Agenda Item: Authorize Change Order No. 3 with LaRiviere, Inc. for the Honeysuckle Avenue and Ramsey Road Roundabout Project for changes related to tree and stump removal, electrical service installation for the center island, and the addition of contract days for a net contract cost increase of \$13,723.10 and three (3) contract days.

CONTRACT CHANGE ORDER NO. 3

PROJECT: 41014.14 - HONEYSUCKLE AVENUE AND RAMSEY ROAD
ROUNABOUT IMPROVEMENTS

SHEET NO. 26

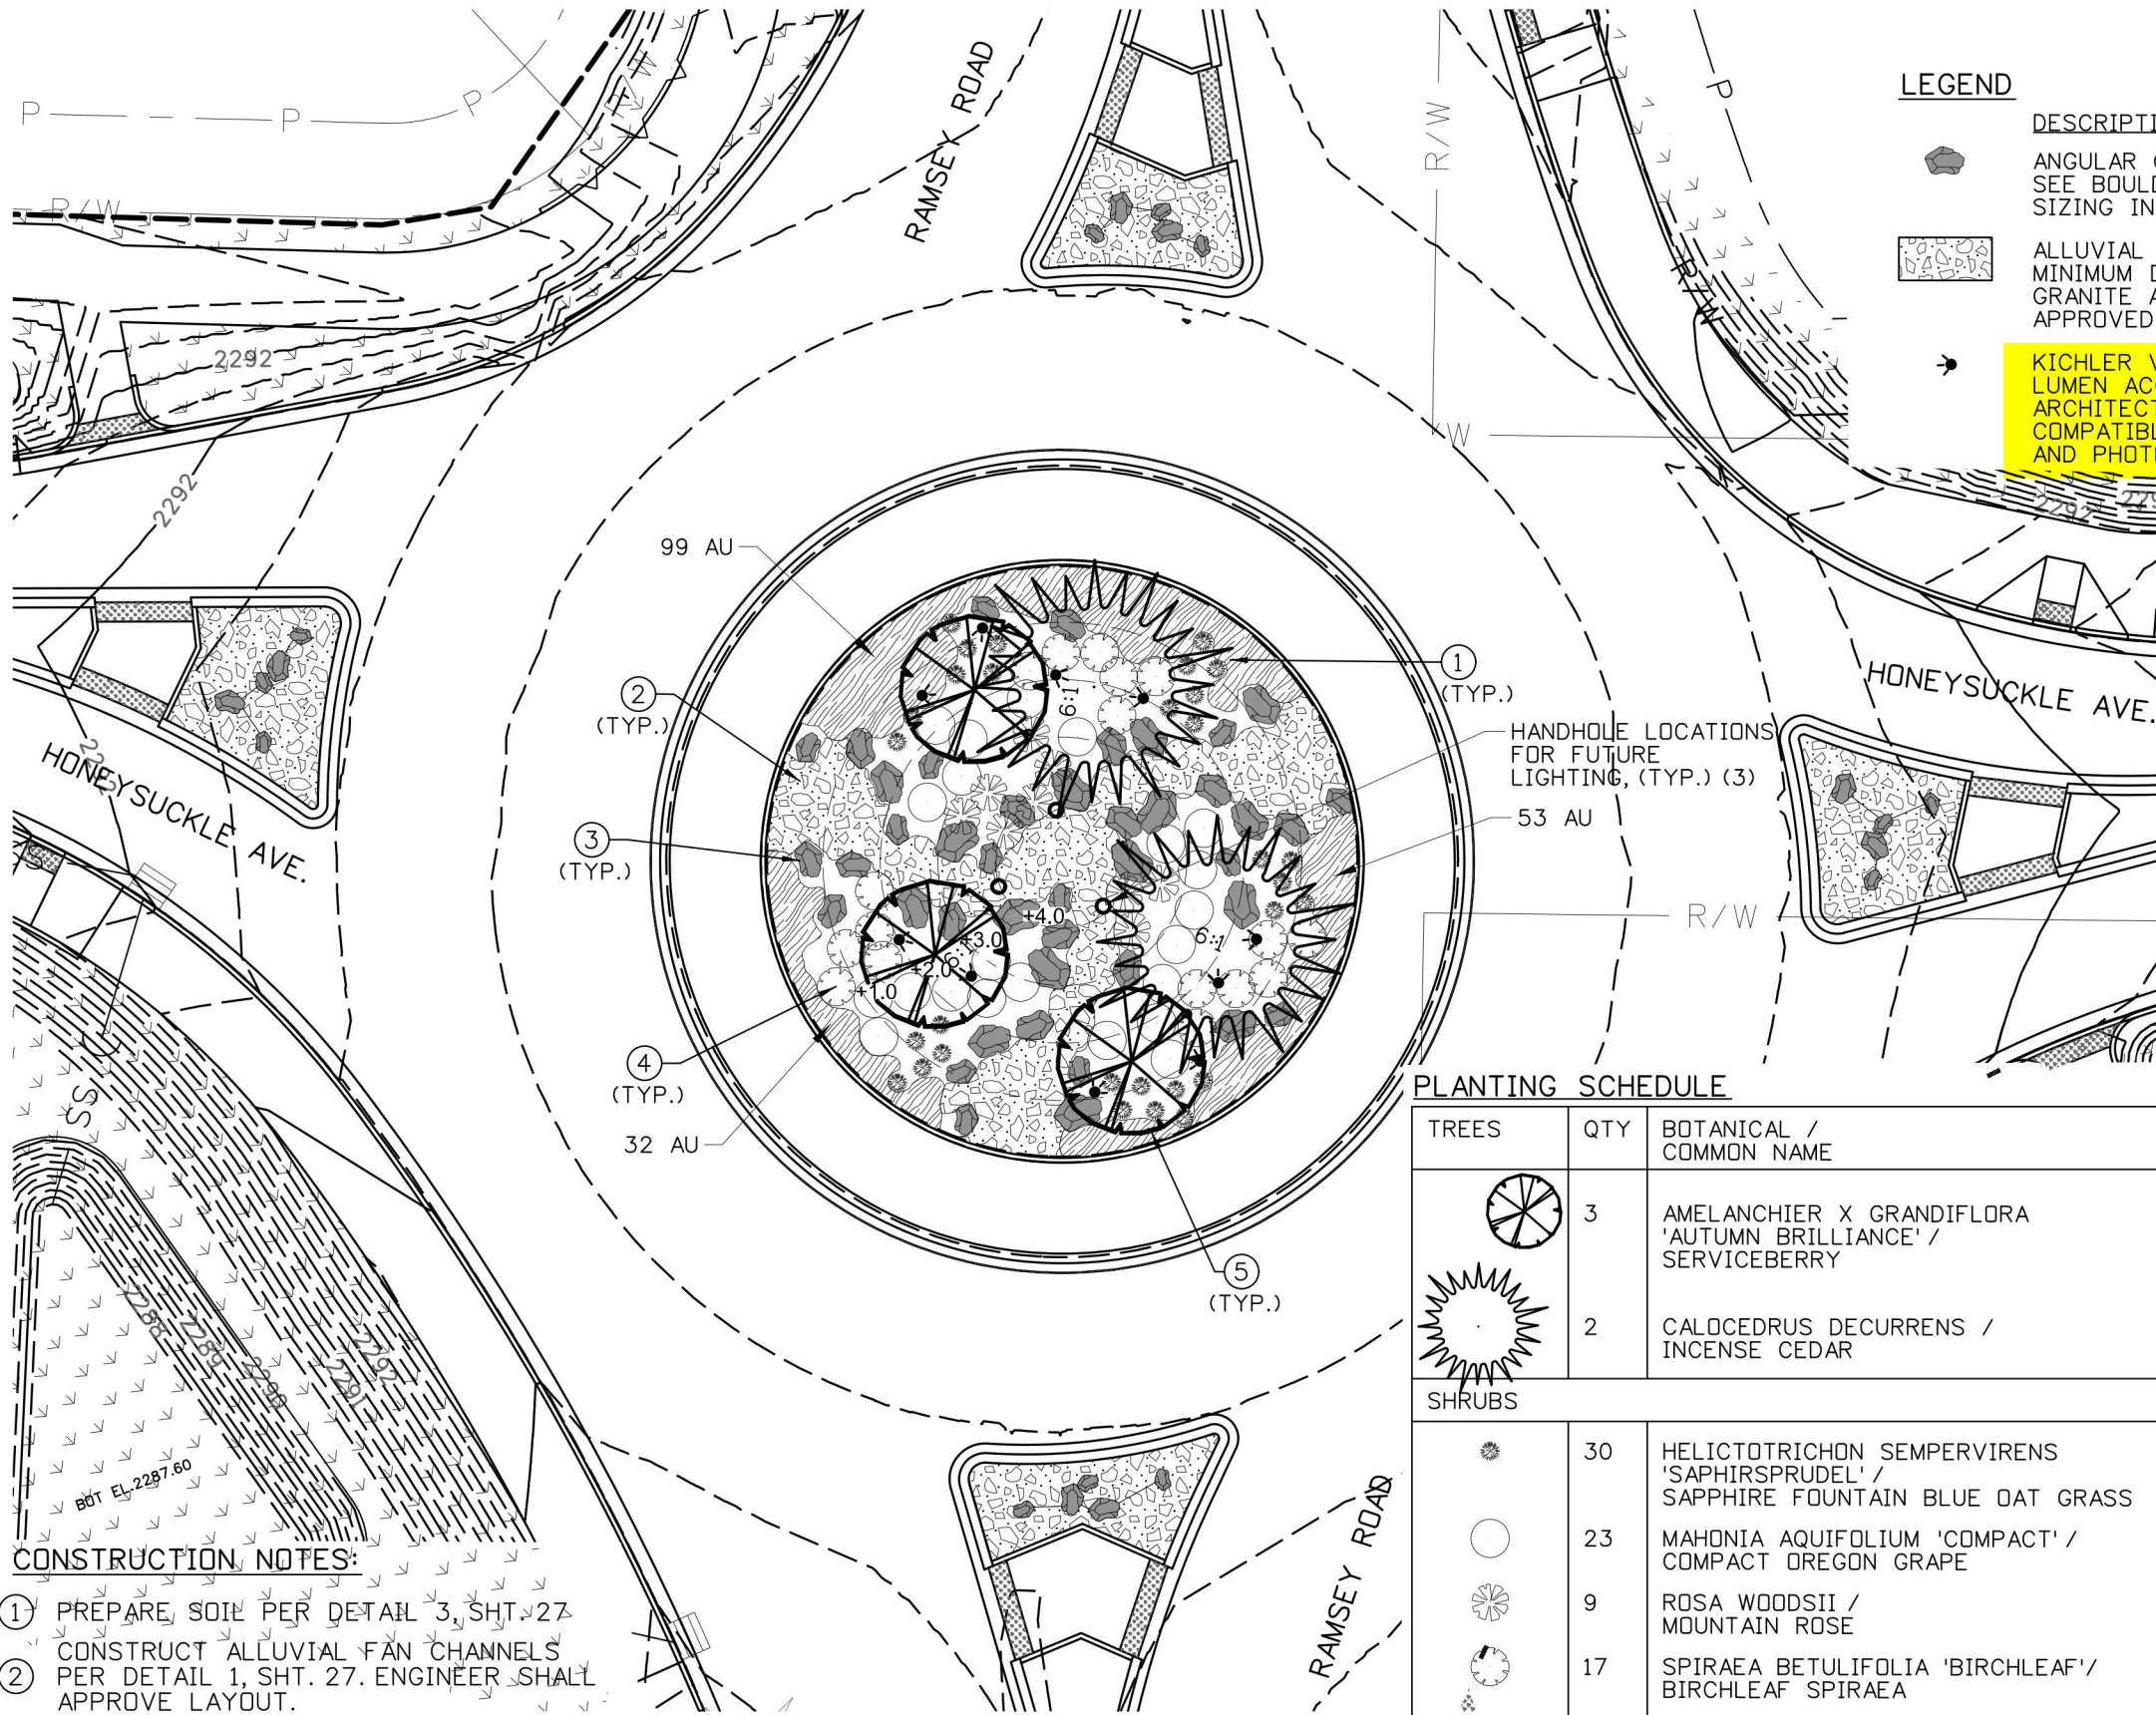
In addendum 2 on sheet 21 it looks like 5 trees were added (Armstrong Maple). On sheet 26 the plant schedule was not updated to reflect these added trees. My question is are there to be a total of 2 Armstrong Maple trees per the original schedule or 7 Armstrong Maples to reflect the 2 original ones and the 5 added on sheet 21?.

I can't find any specific variety of landscape boulders listed in the plans. We quoted the job using either round granite or fractured basalt (size ranging from 1.5' to 5" diameter. Please indicate if either of these are acceptable or suggest an alternative variety if not.

3. Sheet 26's Planting Schedule calls out the 2 Armstrong Maple Trees in the original design. Addendum 2's Sheet 21 added an additional 5 Armstrong Maple Trees, bringing the total to 7. All trees are incidental to SSP208010 Roundabout Landscaping and Lighting.

4. Sheet 26's Legend calls out angular granite boulder outcroppings to be used for the landscape boulders. The boulder schedule provides the size and quantities of the boulders. Round Granite or Angular Basalt may be acceptable, please provide a submittal (photo of proposed boulder types) for review and Owner selection.

SHEET NO. 16

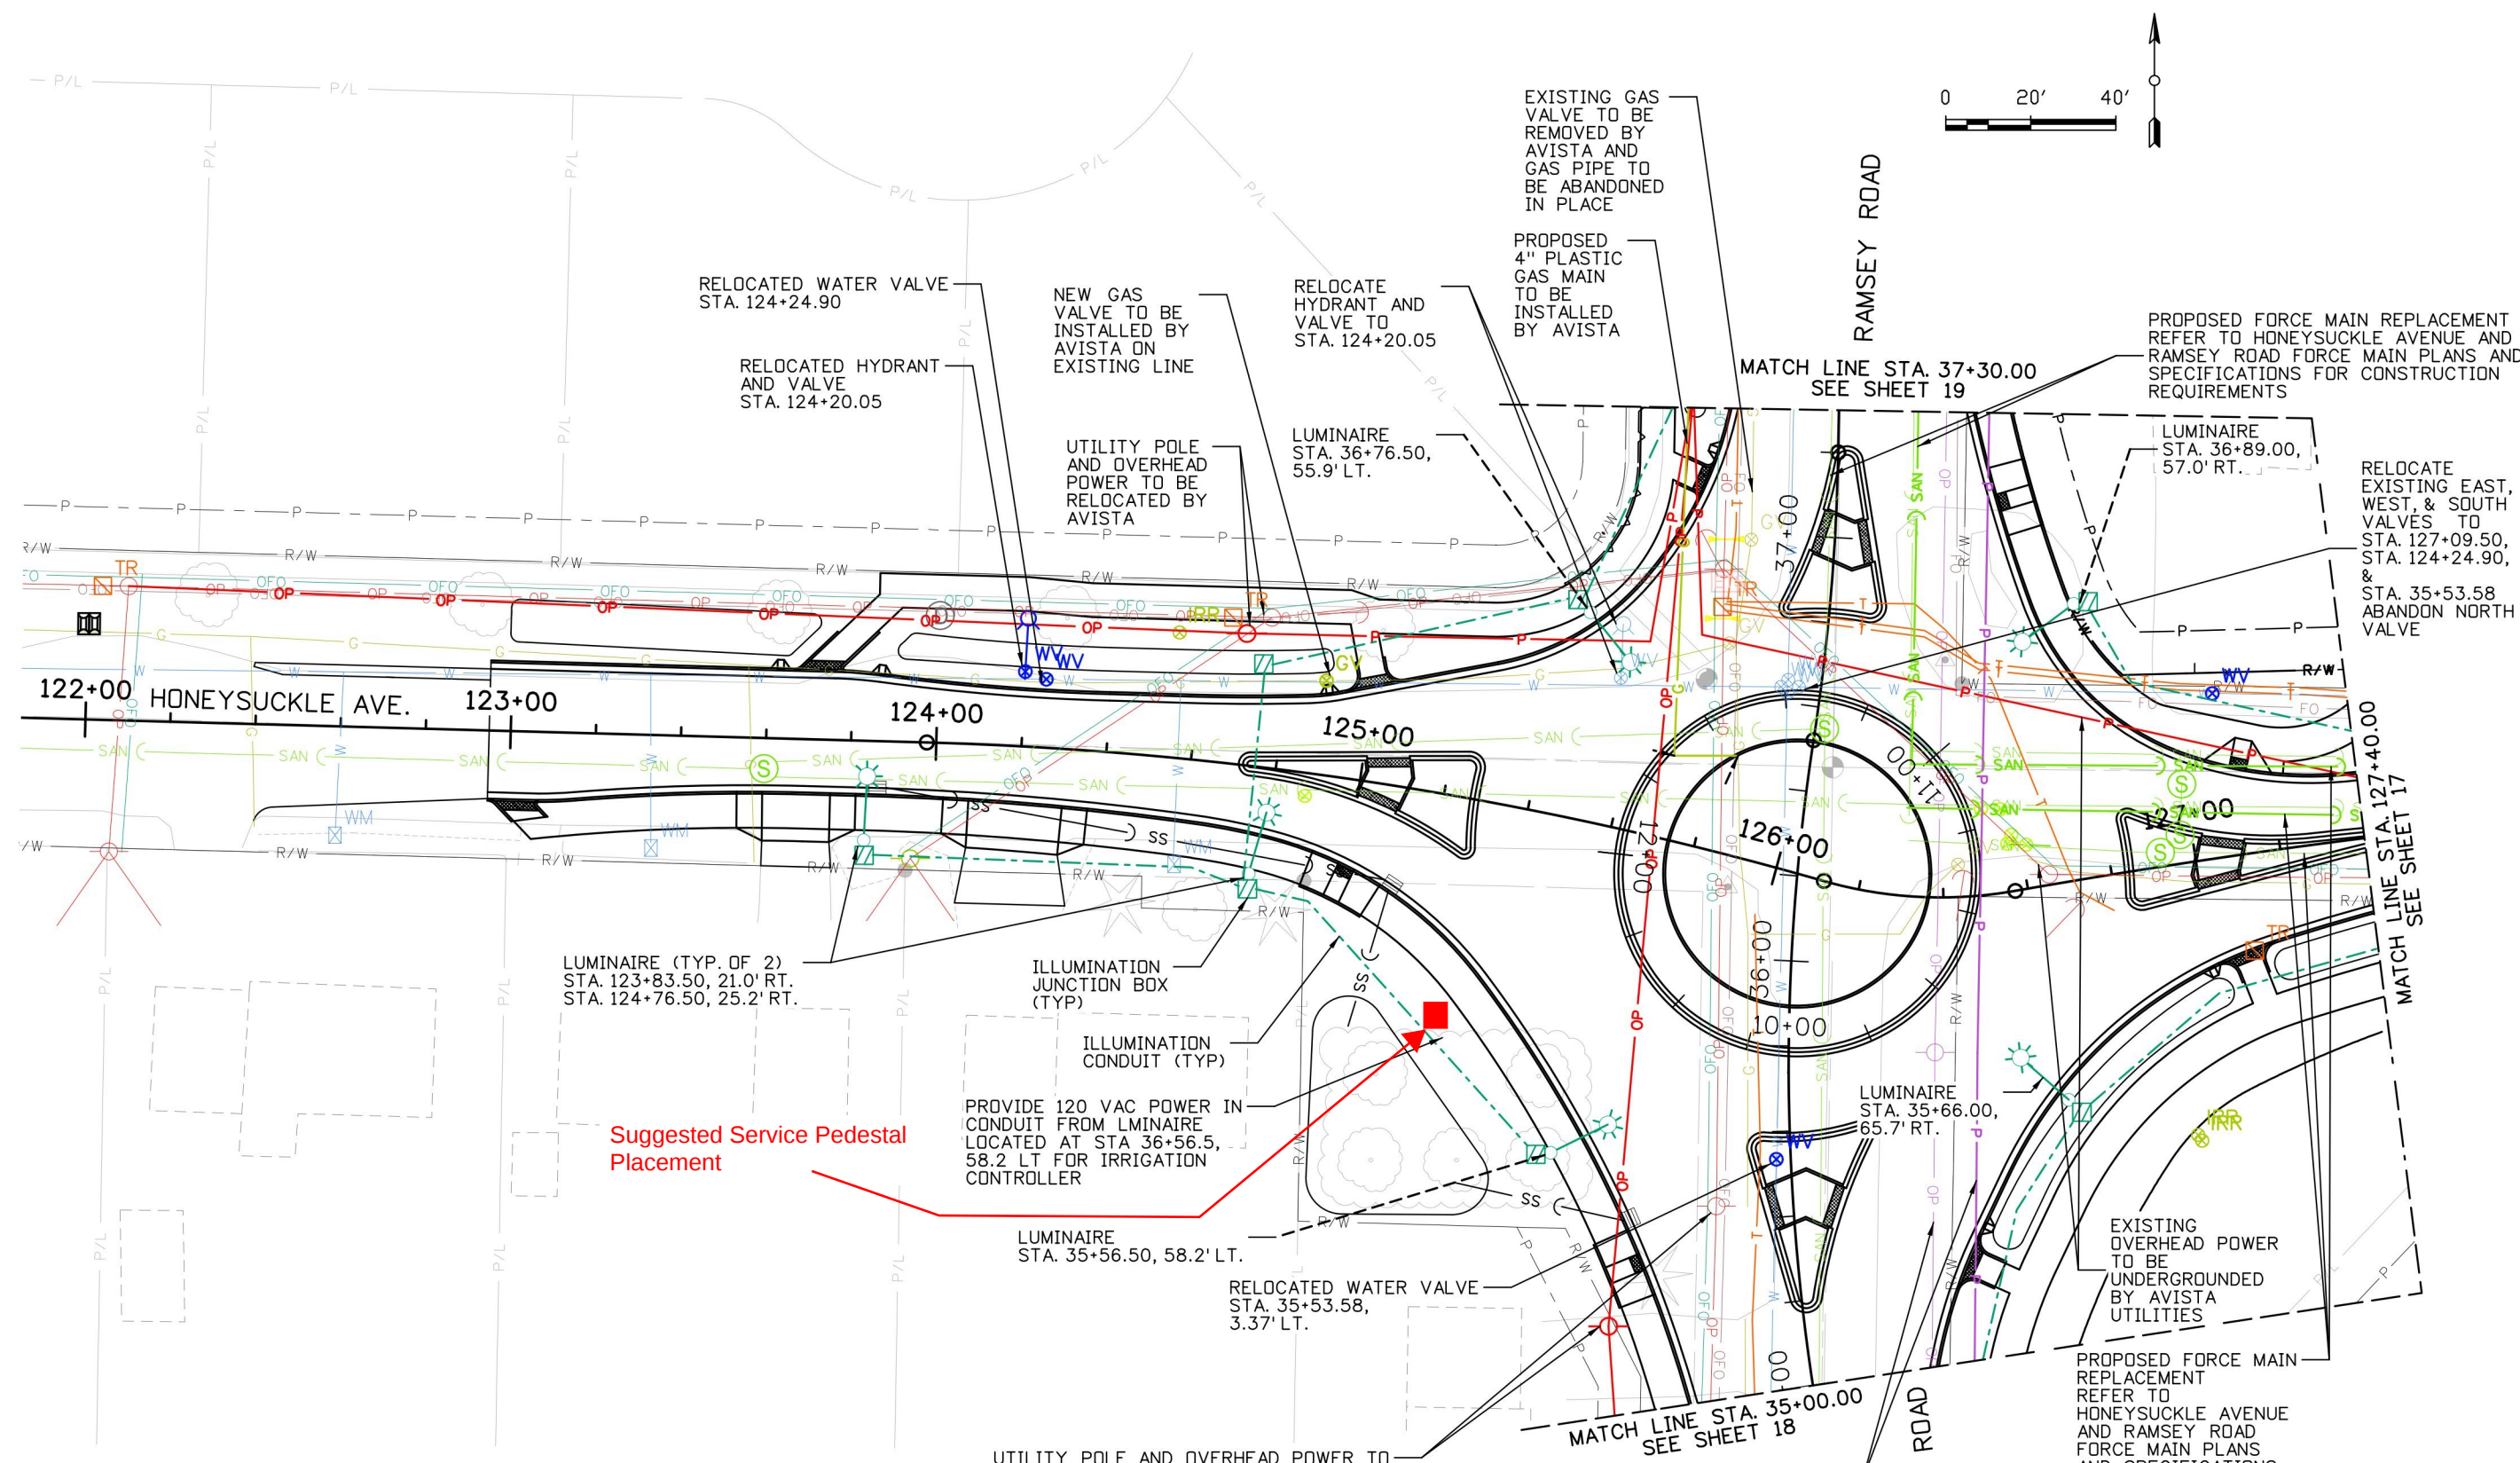
Sheet 16 indicates to provide 120 vac power in conduit from Luminaire for irrigation timer. There is no detail for this indicating whether it needs a separate panel, shutoff switch, etc... Prior to the bid I spoke with Thorco regarding this bid item and they stated there is not enough information/detail provided to bid this item. There is also a power source needed for the outdoor lighting transformer that does not appear to be addressed in the bid documents. Please advise on what is required and what will power the outdoor lighting transformer.

Provide Type 1 Service pedestal and associated components to allow connection of contractor designed and provided lighting system and irrigation system controls per response to RFI 13 and Contractor Change Request dated 8/26/26.
